COUNTY OF RIVERSIDE AIRPORT LAND USE COMMISSION

STAFF REPORT

CASE NUMBER: ZAP1444MA20 – Jared Riemer/PR III/CHI Freeway BC, LLC (Representative: Glassman Planning Associates, MG2, and MIG. Inc.)

JURISDICTION CASE NO: PP14-02 (Plot Plan/Determination of Substantial Conformance No. 2)

SINGLE ACRE DIAGRAM

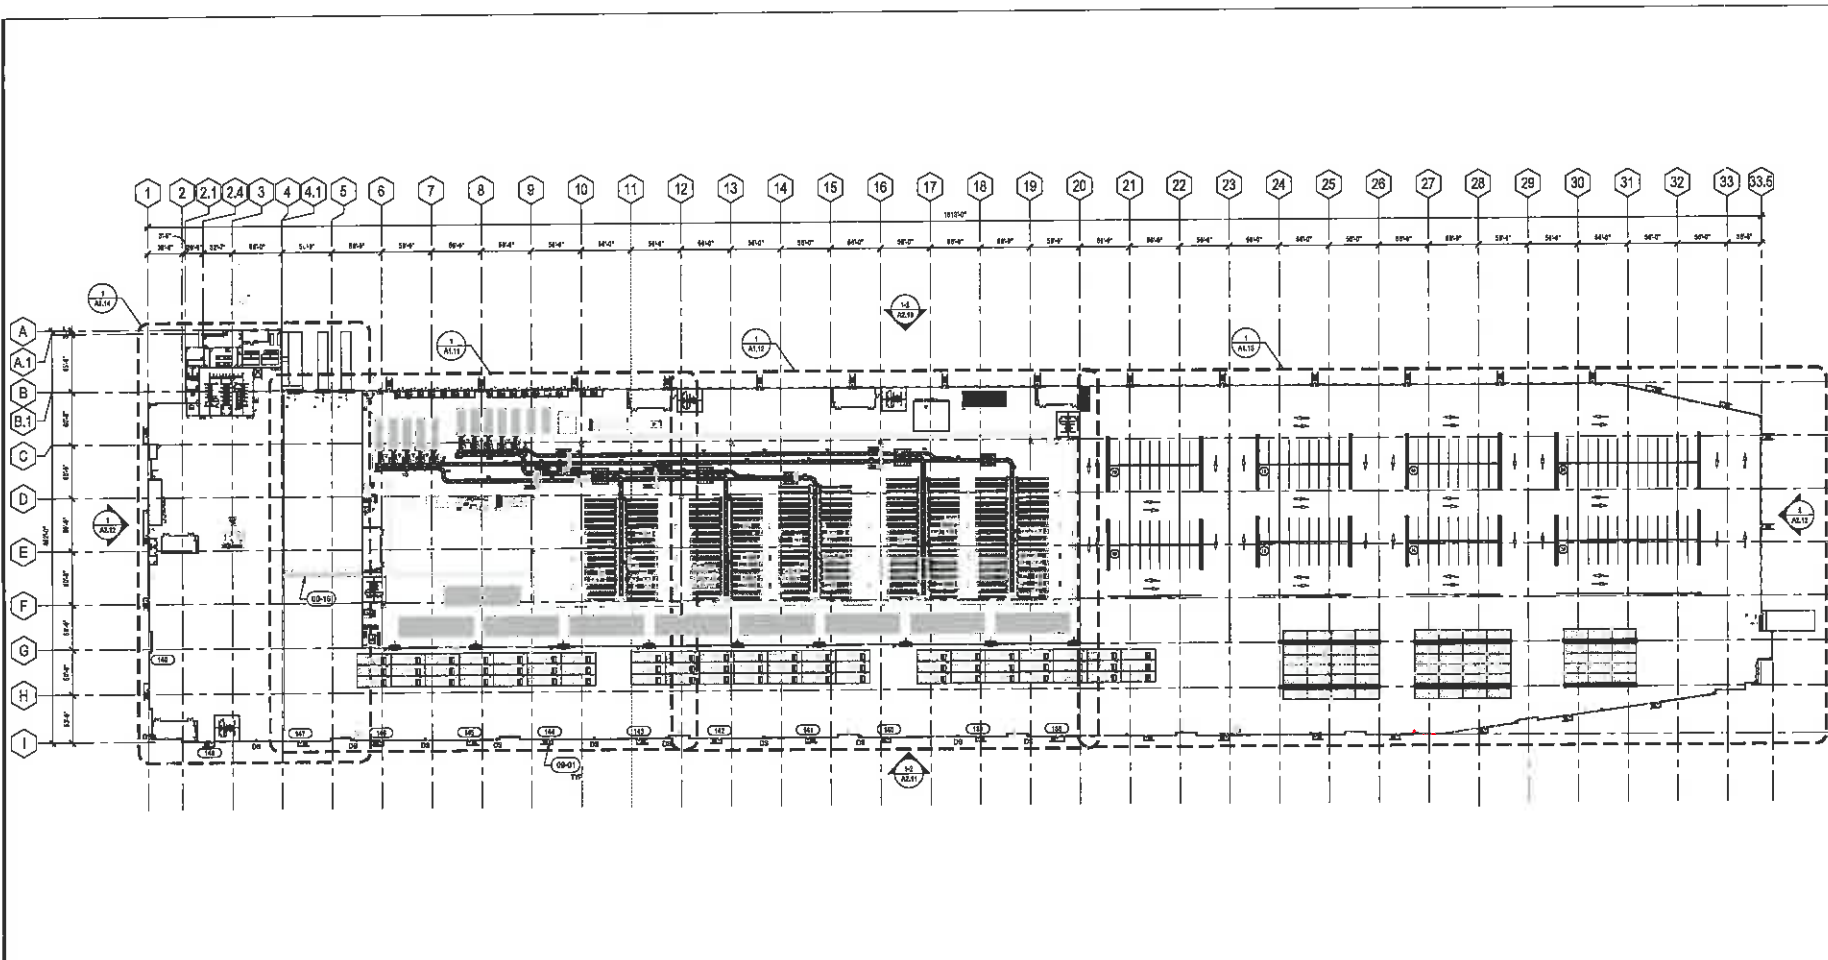
Based on the site plan provided and the occupancies as previously noted, the maximum single-acre intensity in APZ-I includes **42,510 square feet of high-cube warehouse area and 1,050 square feet of break room area**, ~~52~~ **56** indoor van parking spaces for a total occupancy of ~~52~~ **56** ~~100~~ people, which is consistent with the Compatibility Zone B1-APZ-I single acre intensity criterion of 100.

Based on the site plan provided and the occupancies as previously noted, the maximum single-acre intensity in APZ-II includes a ~~1,500~~ **5,400** **42,510 square feet of high-cube warehouse area and 1,050 square feet of break room area**, ~~24,800~~ **24,579** (~~previously unidentified floor area~~) for a total occupancy of ~~100~~ **377** ~~100~~ people, which is consistent with the Compatibility Zone B1-APZ-I
